Contract #: 04-0120F4Cty: SF/ALA Rte: 80 PM: 13.2/13.9File #: 69.25B**QUALITY ASSURANCE -- NON-CONFORMANCE REPORT****Location:** Changxing Island, Shanghai, China**Report No:** NCR-000779**Prime Contractor:** American Bridge/Fluor Enterprises, a JV**Date:** 28-Jun-2010**Submitting Contractor:** Zhenhua Port Machinery Company, Ltd (ZPMC), Changxing Island**NCR #:** ZPMC-0741**Type of problem:**

Job Name: SAS Superstructure
Document No: 05.03.06-000737

Ref: 05.03.06-000737

Welding Repair Report

WELD NUMBER: 21TR4-003-005

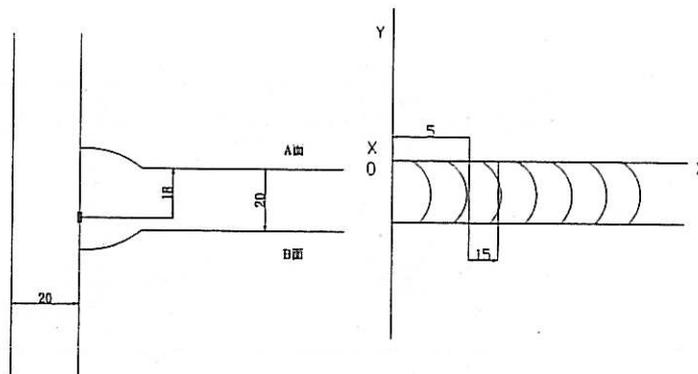
Rejected indication found by ultrasonic inspection is less than the maximum allowance aggregate length.

(UT探伤发现的缺陷总长度小于最大允许长度。) 21TR4-003-005

1. Did not clear the weld pass completely in time.

1. Gouge or grind from nearer side from metal edge ($D \leq 0.65T$, "D" is depth of defects, "T" is thickness of metal) to remove all defects;
2. Follow repair WPS for joint preparation, preheat, and weld deposit;
3. Verify with VT no defects remain in the weld joint prior to welding;
4. Grind the repaired area flush with base metal or the adjacent weld;
5. Check the welds according to the working drawings.
